ADDENDUM NO. 1

Date of Addendum: March 18, 2016

PROJECT NAME: Neighborhood Street Reconstruction Project No. 467

PROJECT NO: WBS No. N-000400-0001-4

WBS NUMBER
N-000400-0001-4
DRAWING SCALE
VERT. 1"=2' HORIZ. 1"=20'
CITY OF HOUSTON PM
BEN BANSAL, P.E.
SHEET No. 43 OF 226

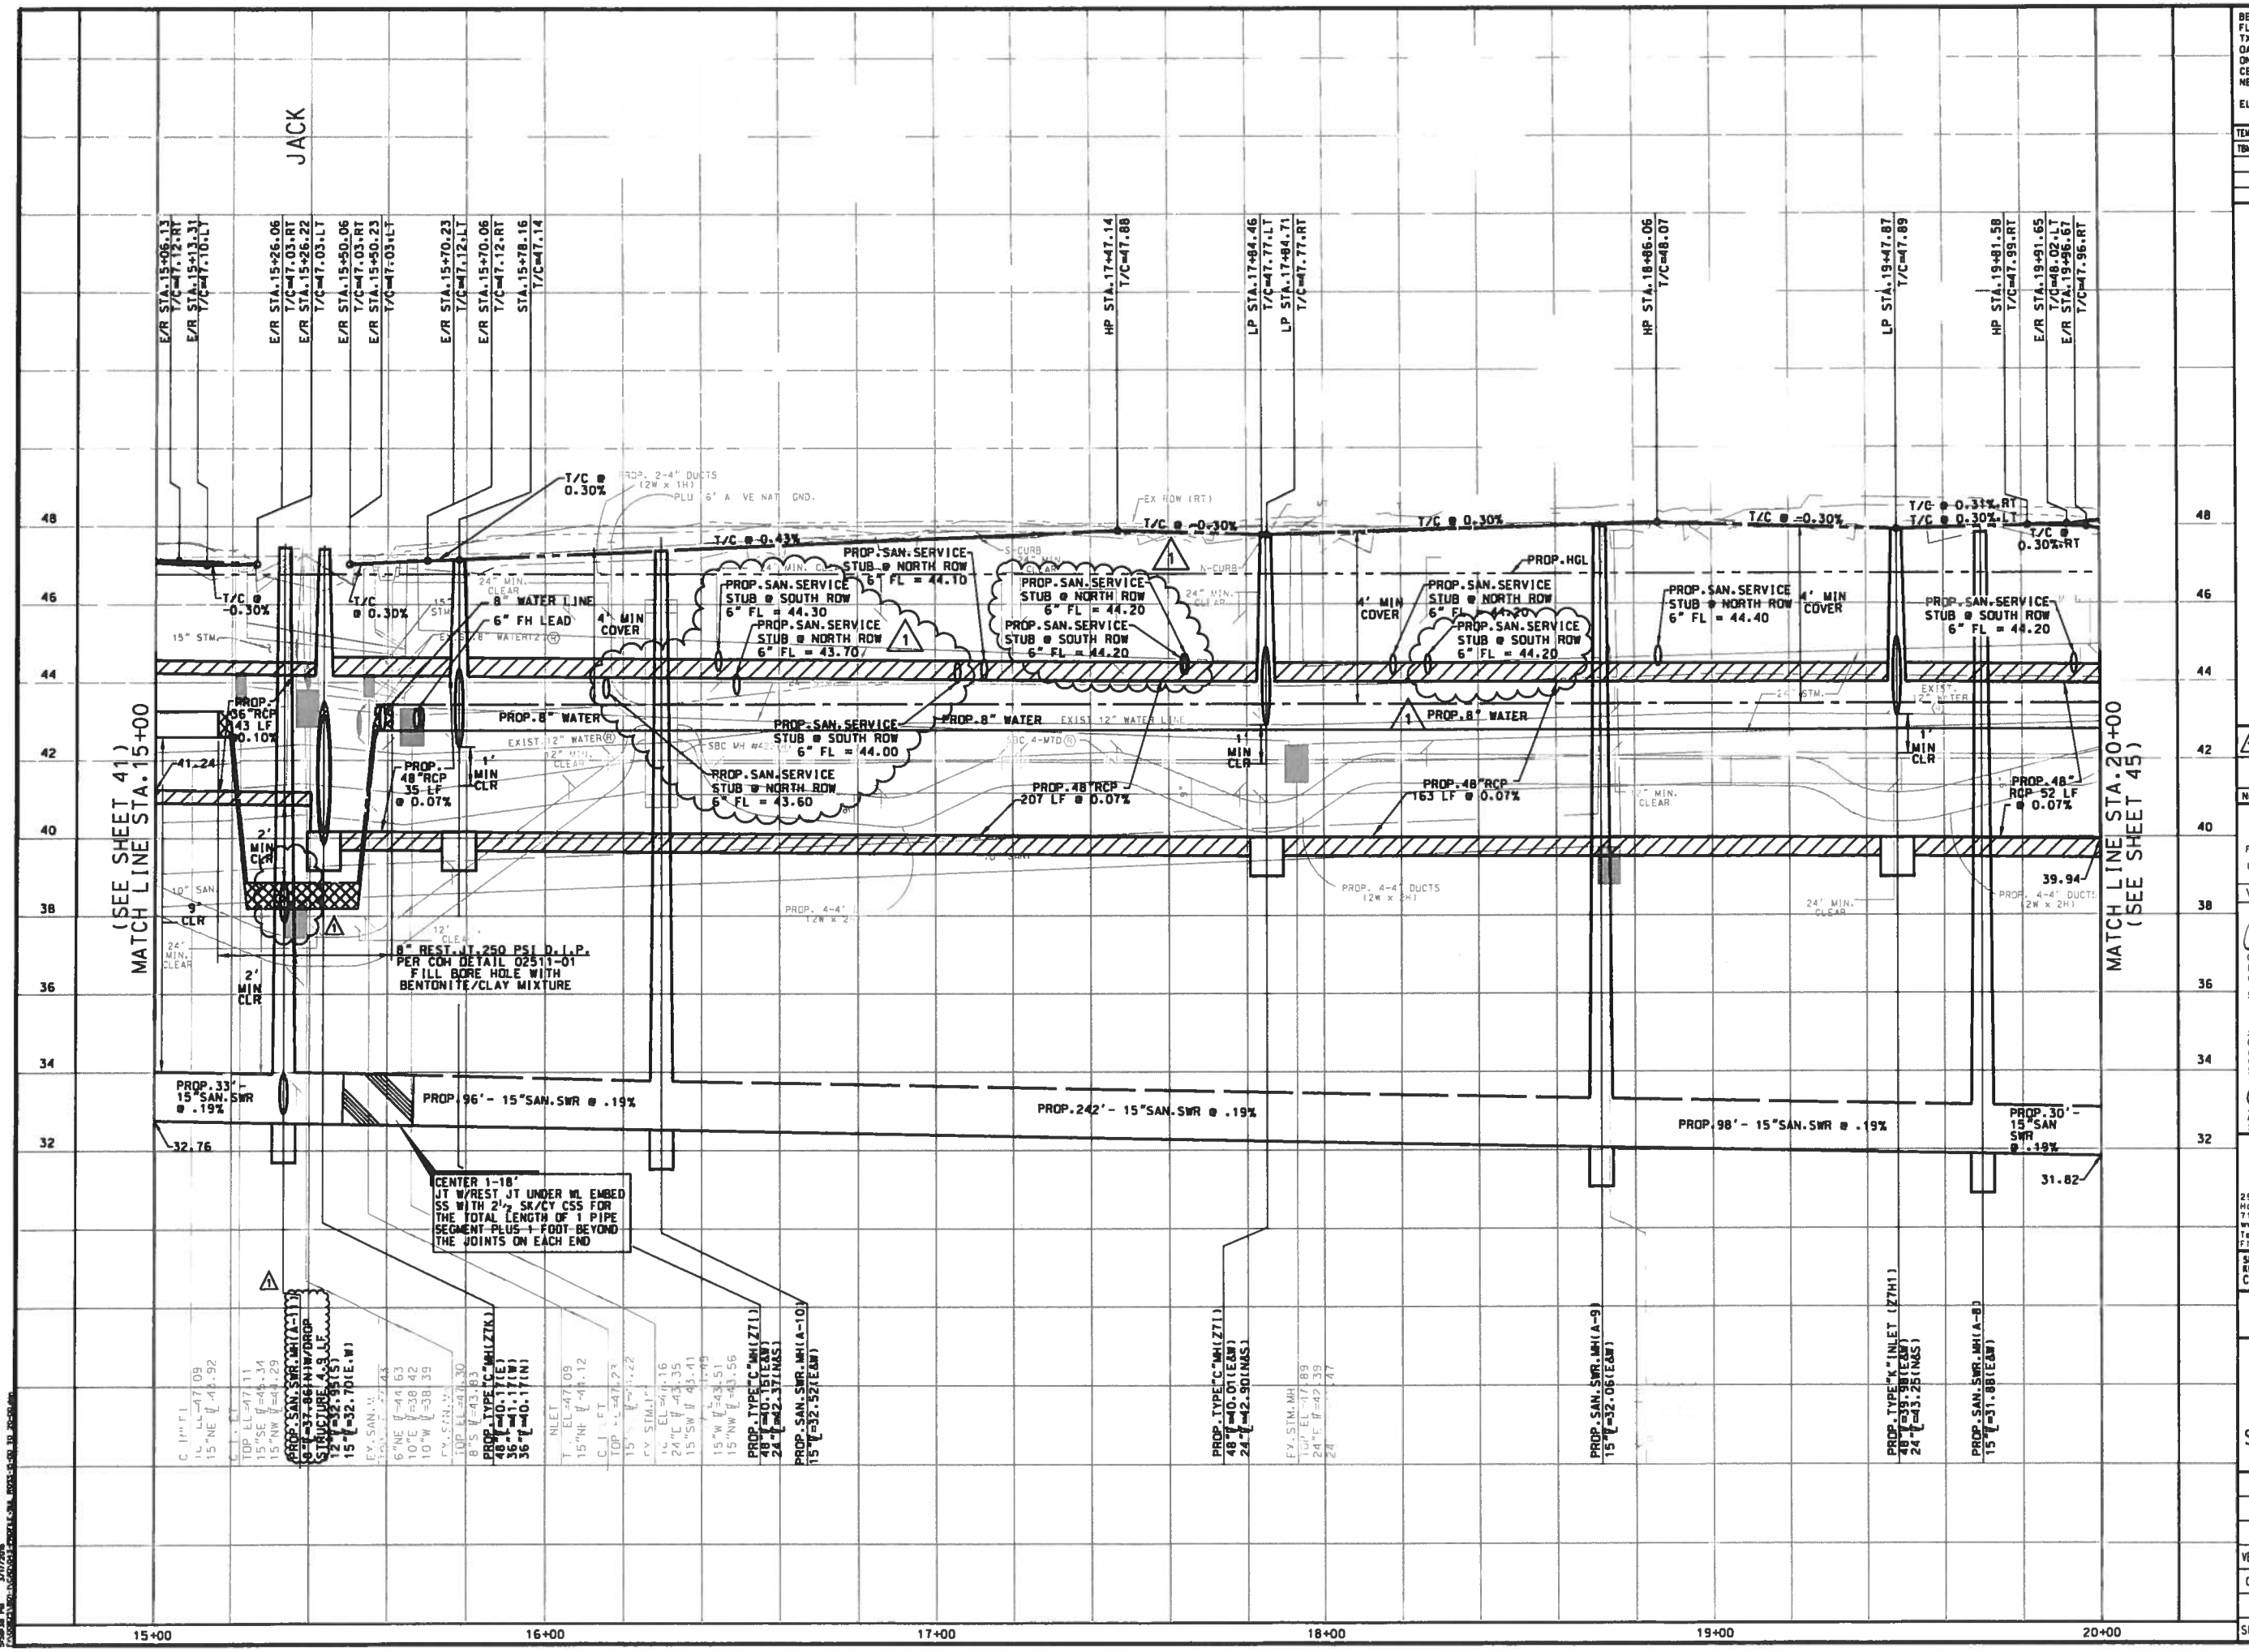
No.	DATE	REVISIONS	APP.
1	3/11	ADDENDUM #1 SAN.SWR. & SERVICE STUB REVISED	M.A.M.

WBS NUMBER
N-000400-0001-4
DRAWING SCALE
VERT. 1"=2' HORIZ. 1"=20'
CITY OF HOUSTON PM
BEN BANSAL, P.E.
SHEET No. 44 OF 226

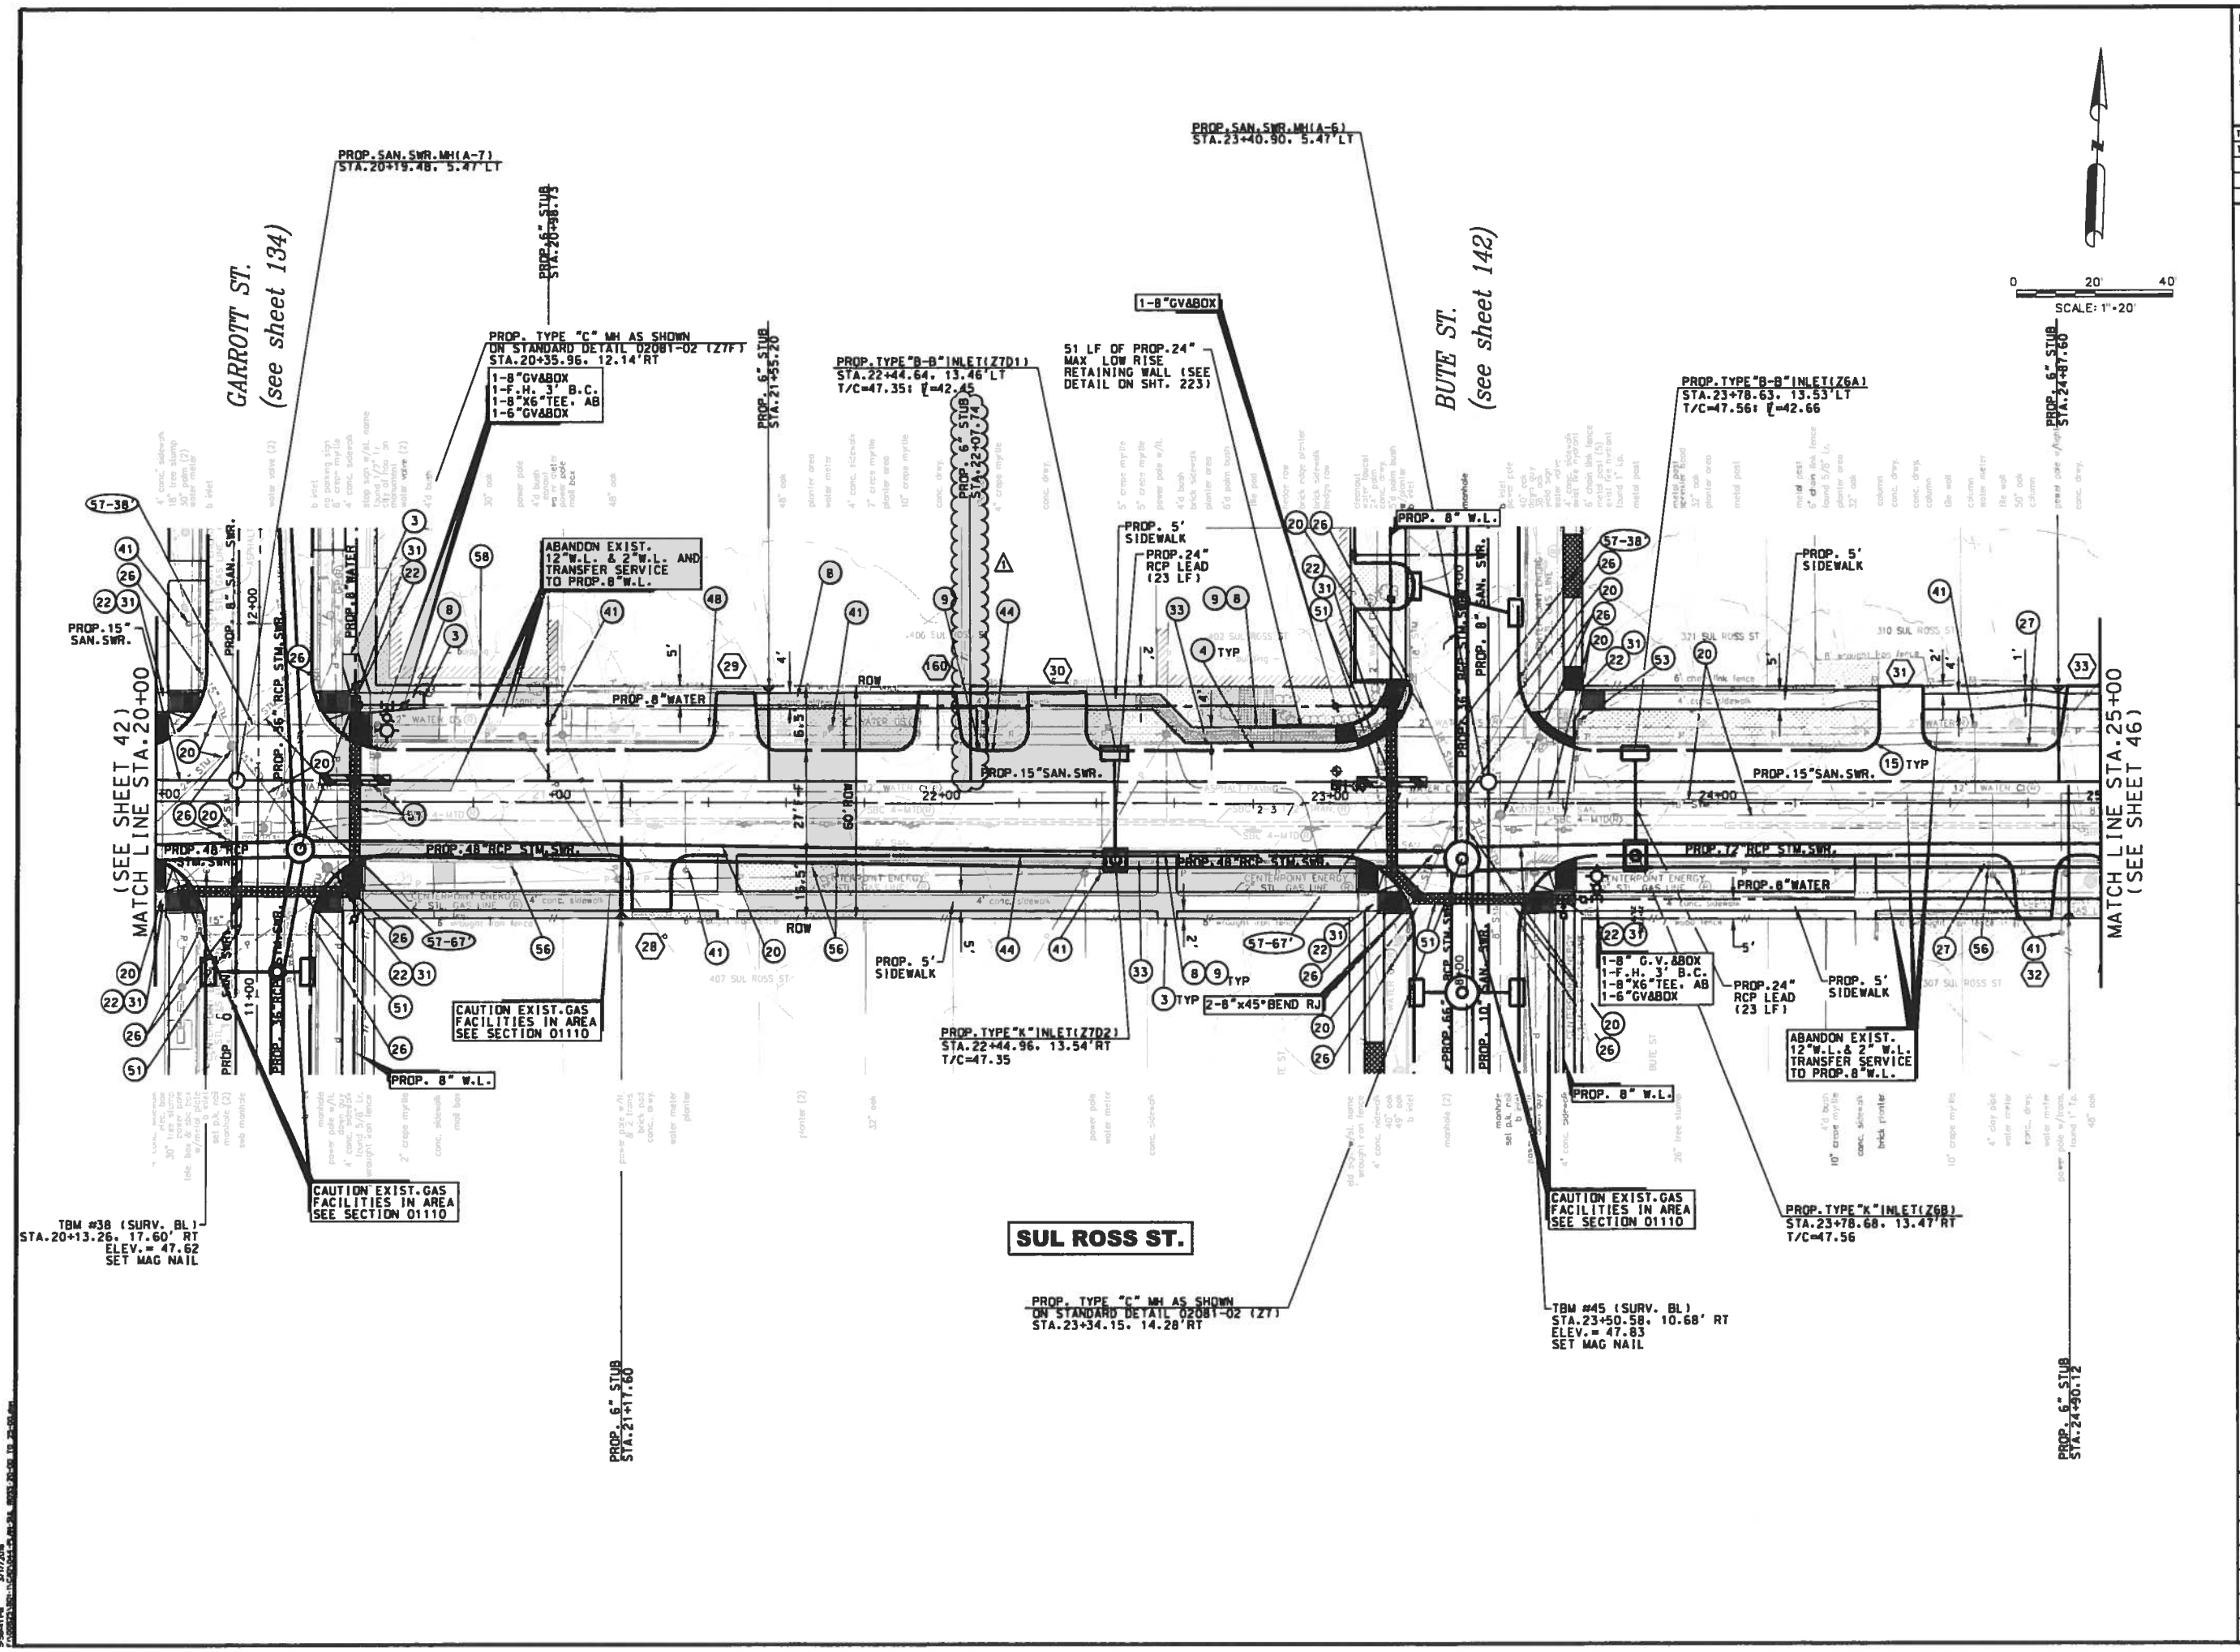
No.	DATE	REVISIONS	APP.
1	3/11	ADDENDUM #1 SERVICE STUBS REVISED	M.A.M

WBS NUMBER	N-000400-0001-4
DRAWING SCALE	VERT. 1"=2' HORIZ. 1"=20'
CITY OF HOUSTON PM	BEN BANSAL, P.E.
SHEET No. 45 OF 226

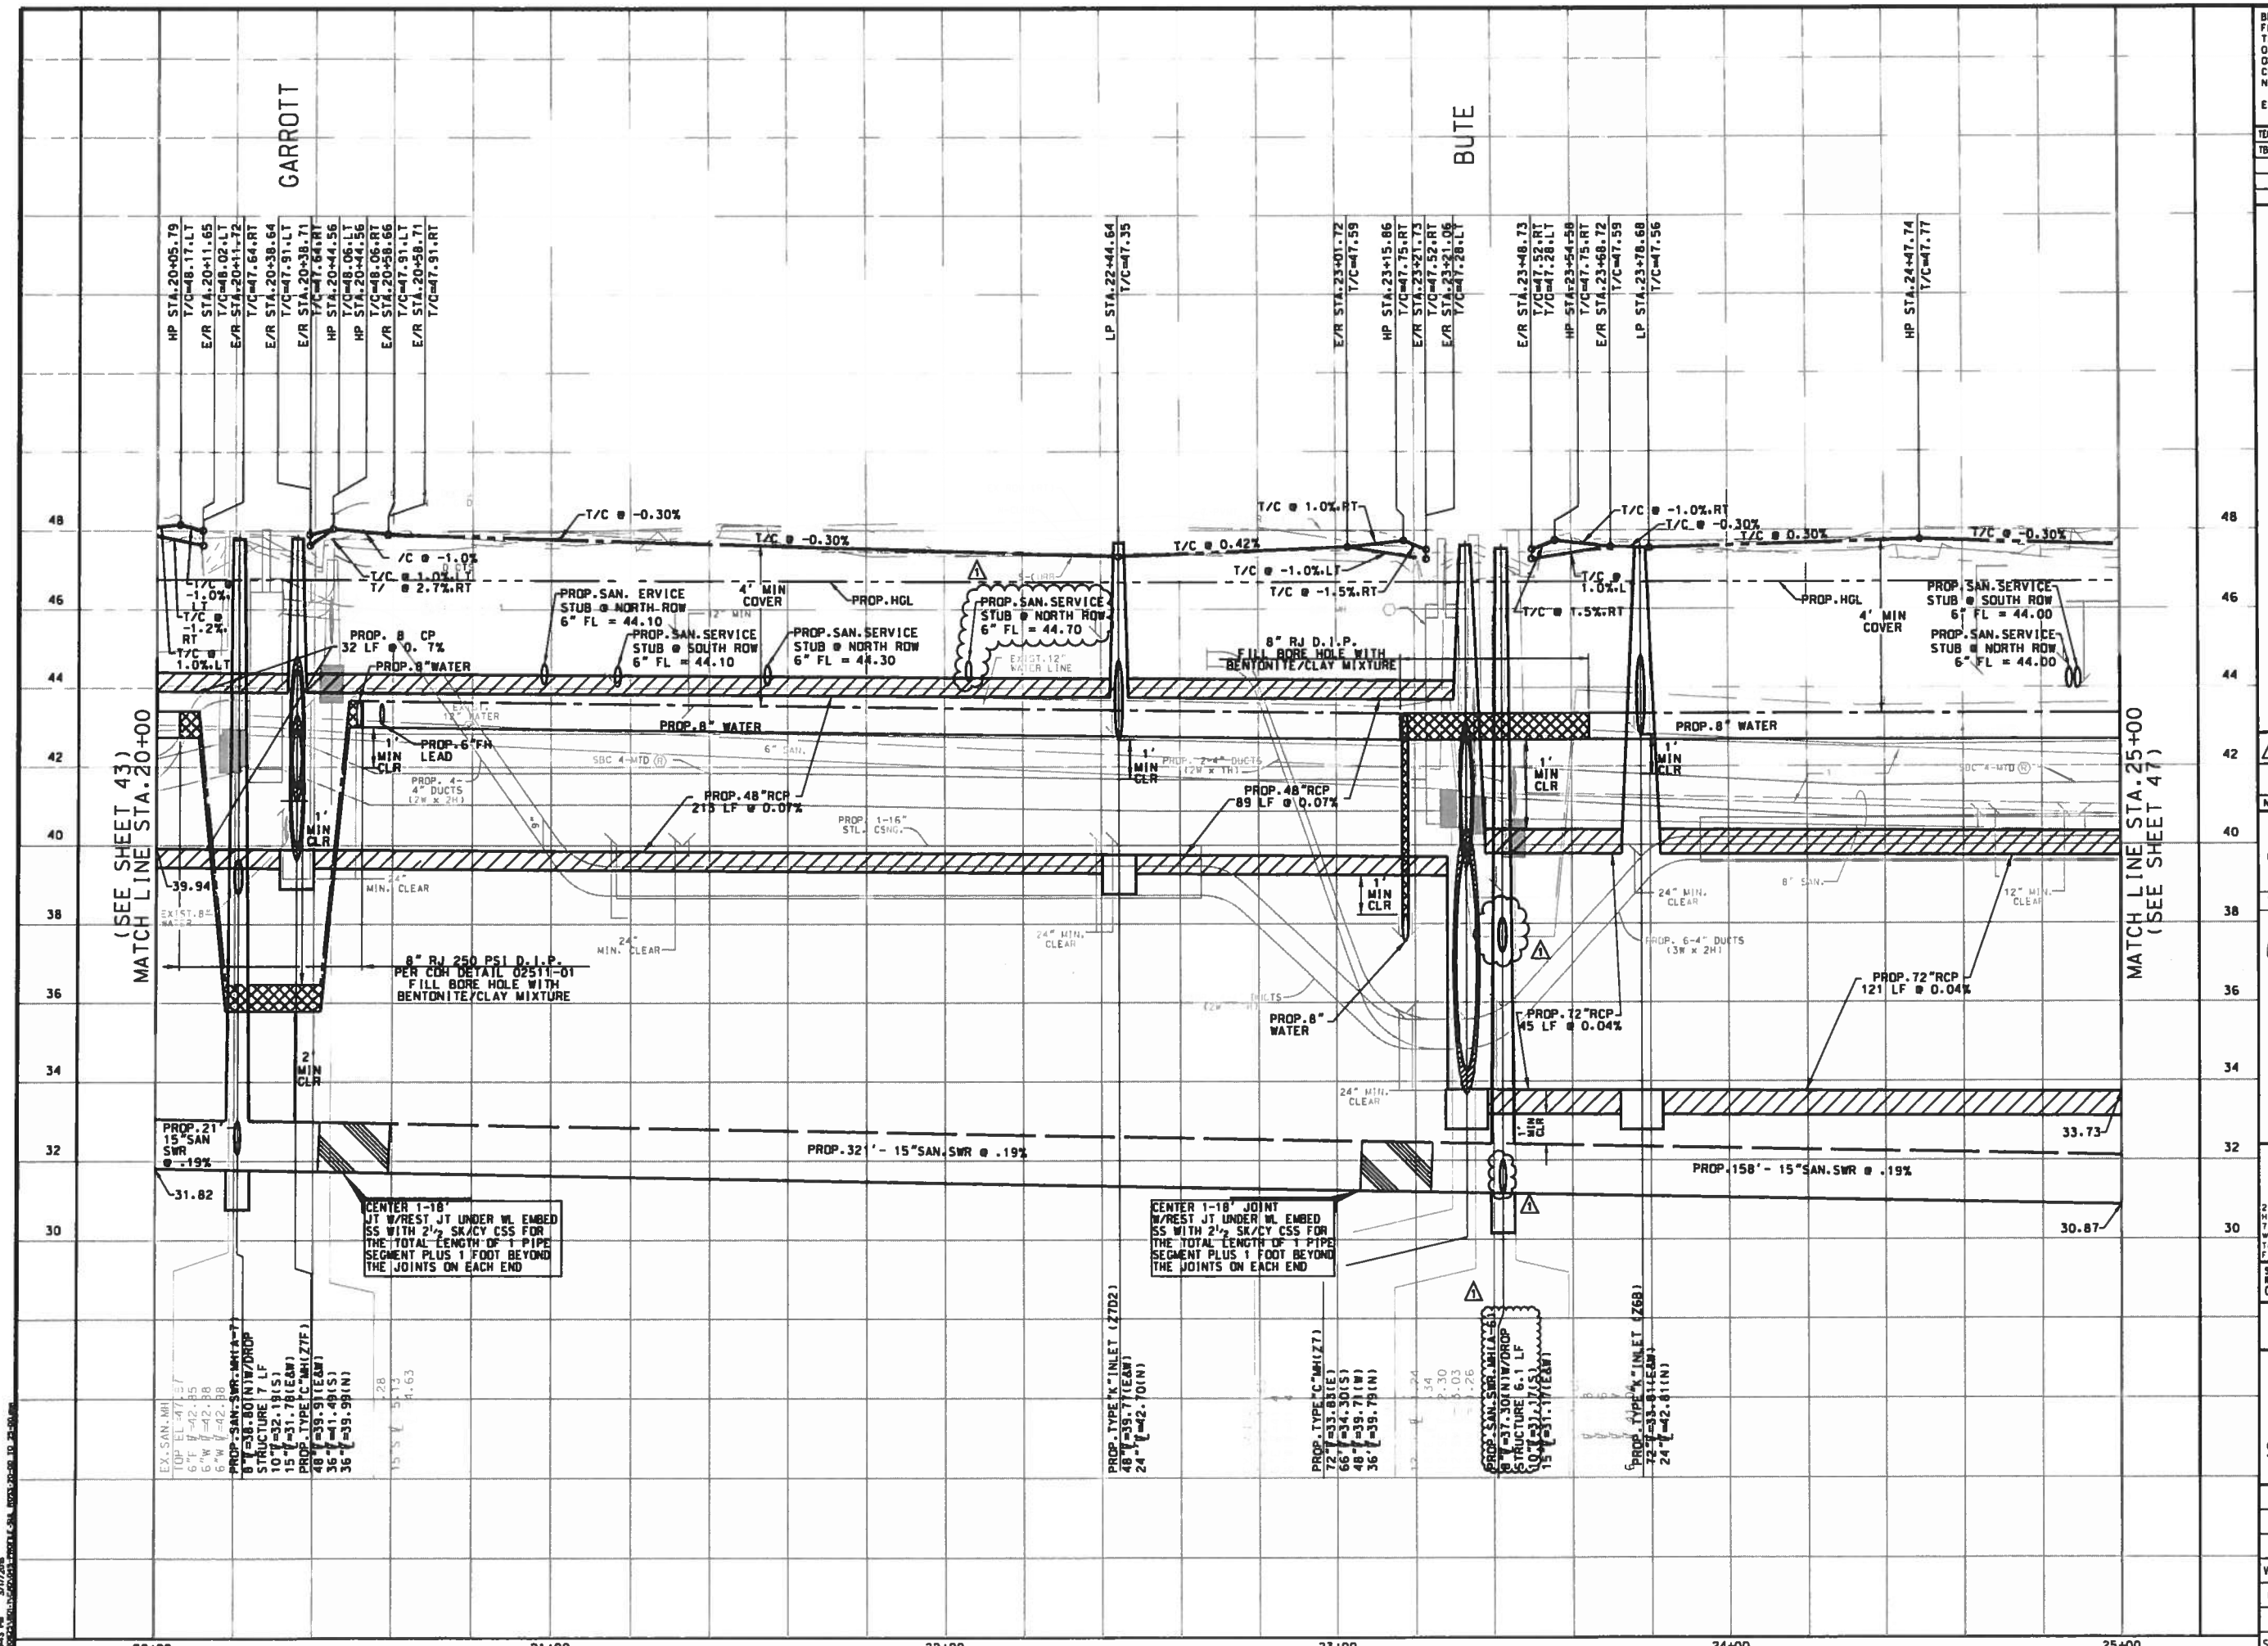
No.	DATE	REVISIONS	APP.
1	3/11	ADDENDUM #1 SAN.SWR. & SERVICE STUB REVISED	M.A.M.
